DRAINAGE INFORMATION SHEET

RE: DRAINAGE PLAN FOR BUILDING ADDITION TO LIN'S ORIENTAL RESTAURANT
(J-21/D28) ENGINEER'S STAMP DATED SEPTEMBER 18, 1987

GRADING AND DRAINAGE PLAN
FOR BUILDING ADDITION TO
LIN'S ORIENTAL RESTAURANT
1035 JUAN TABO BLVD.
ALBUQUERQUE, NEW MEXICO

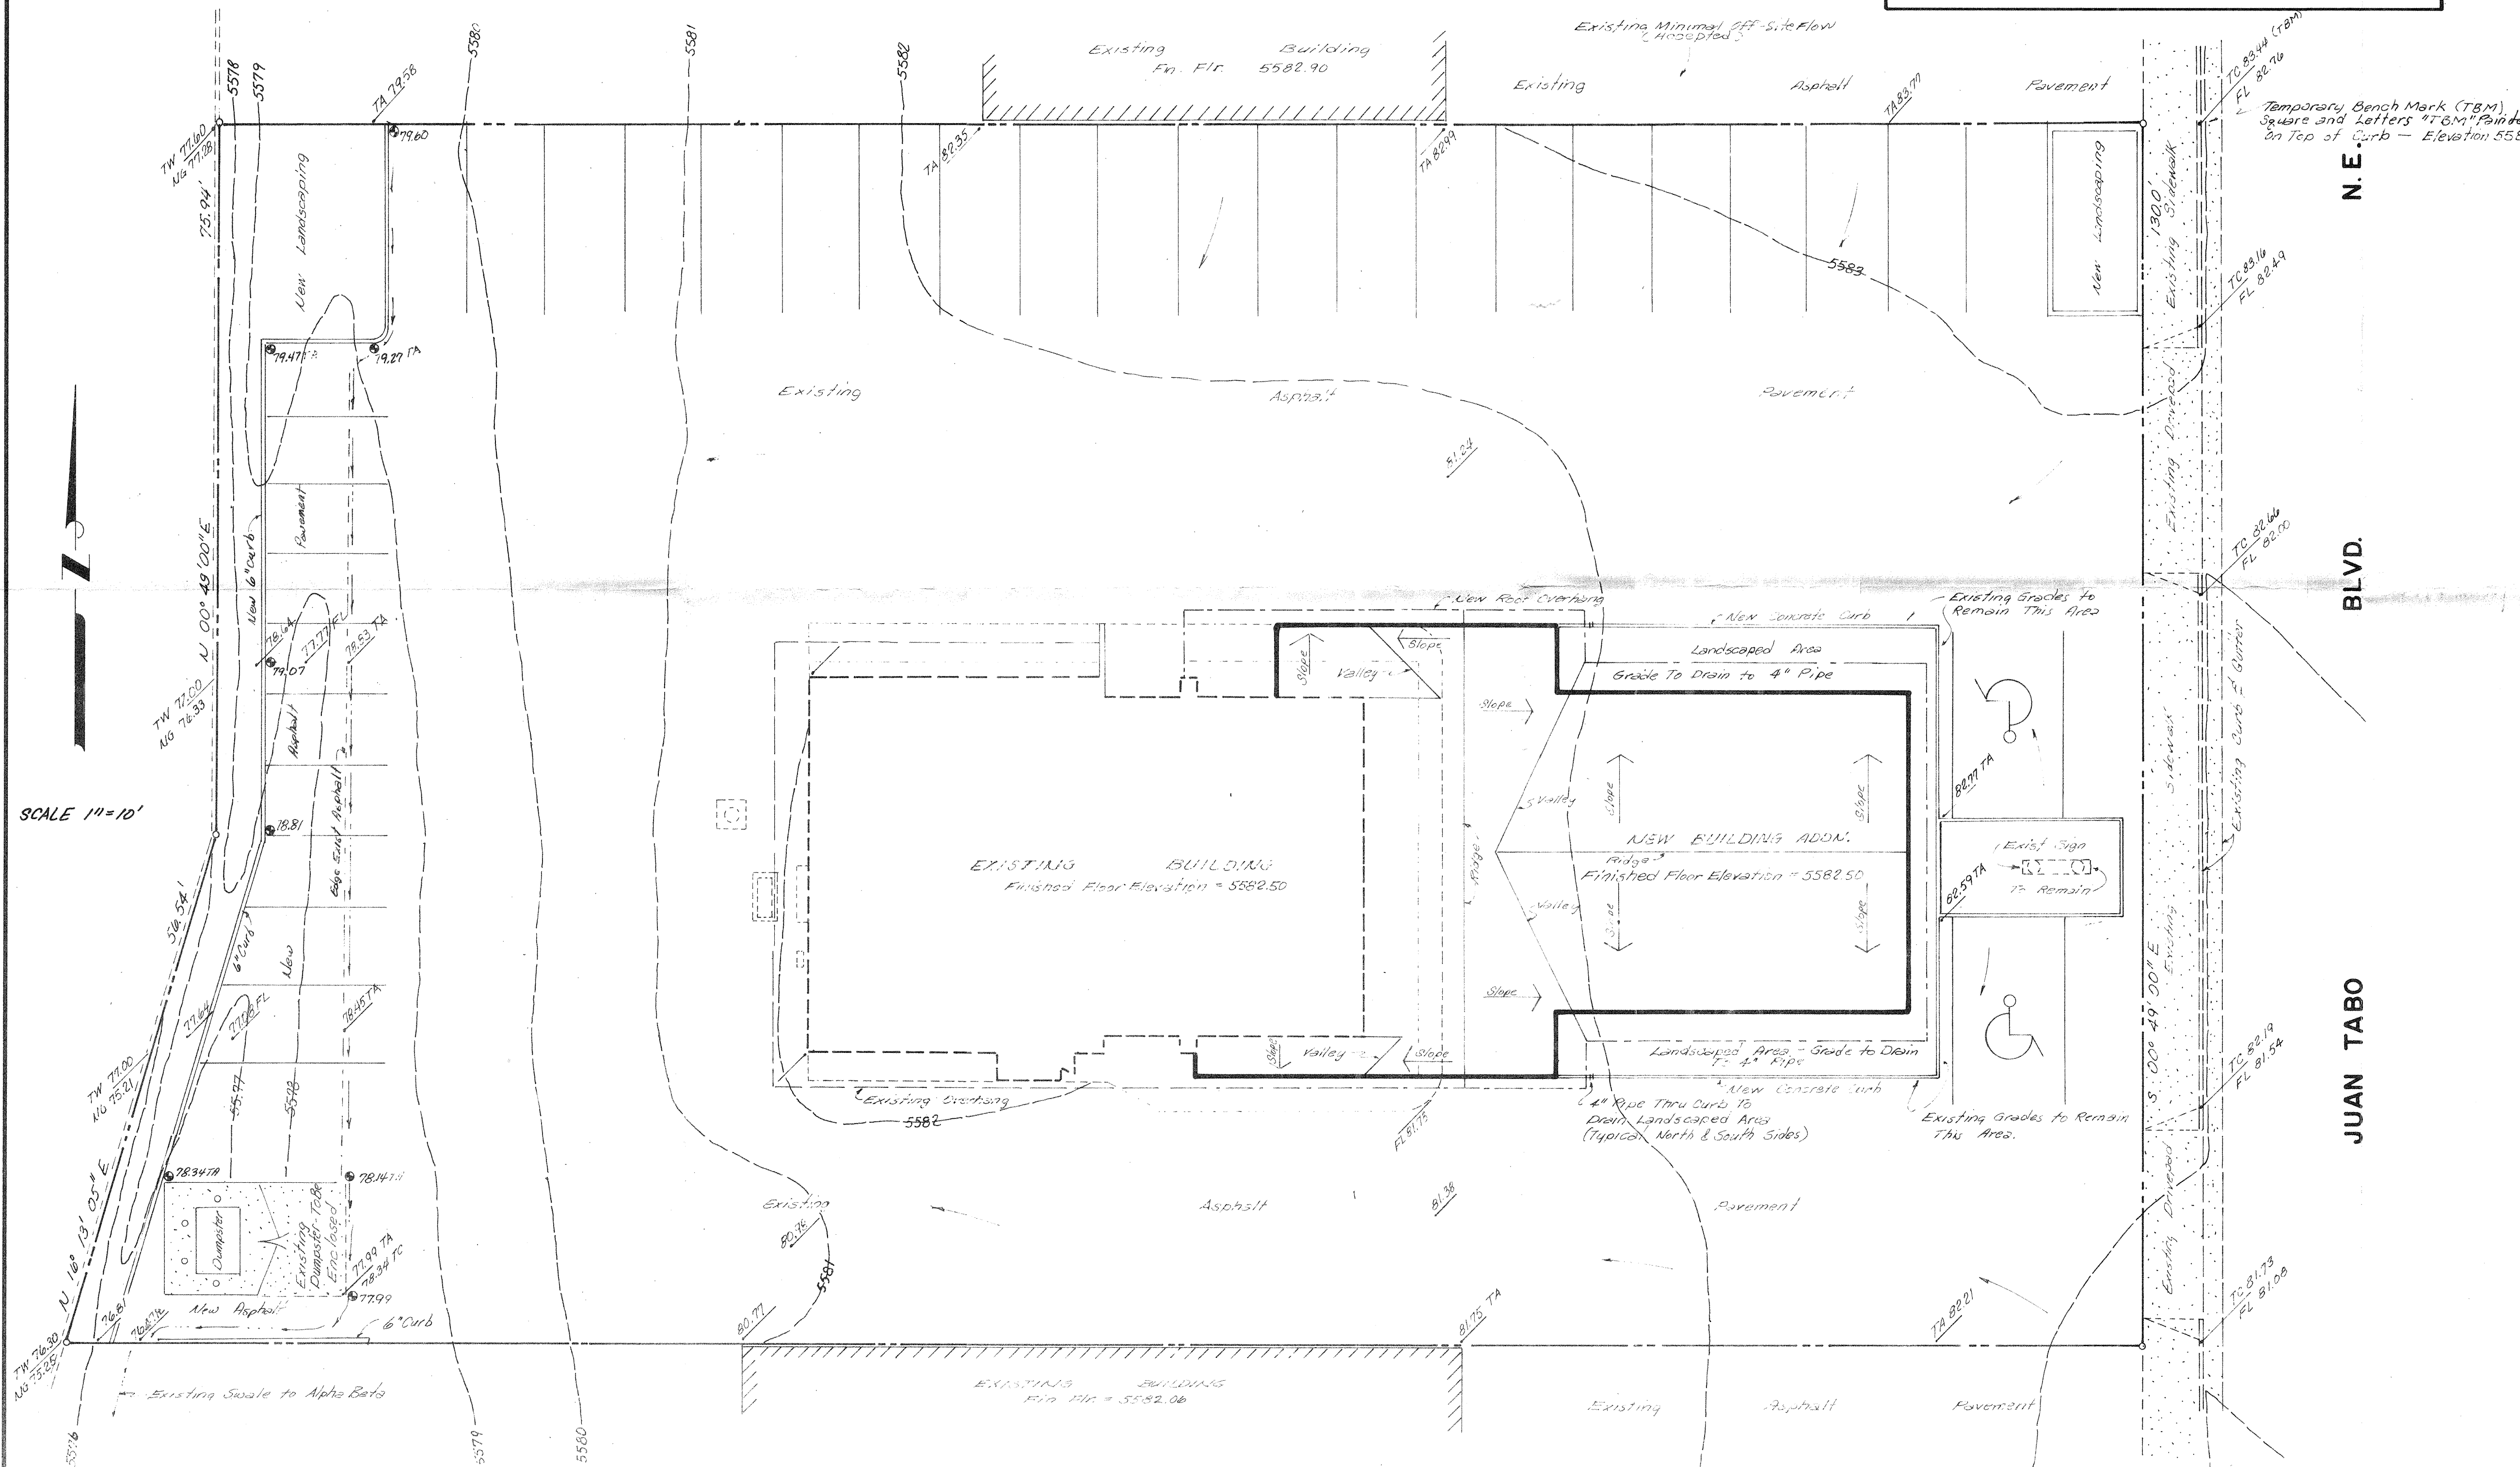
Based on the information provided on your submittal of September 18, 1987, the above referenced plan is approved for Building Permit.

Please attach a copy of this plan to the construction sets prior to sign-off by Hydrology.
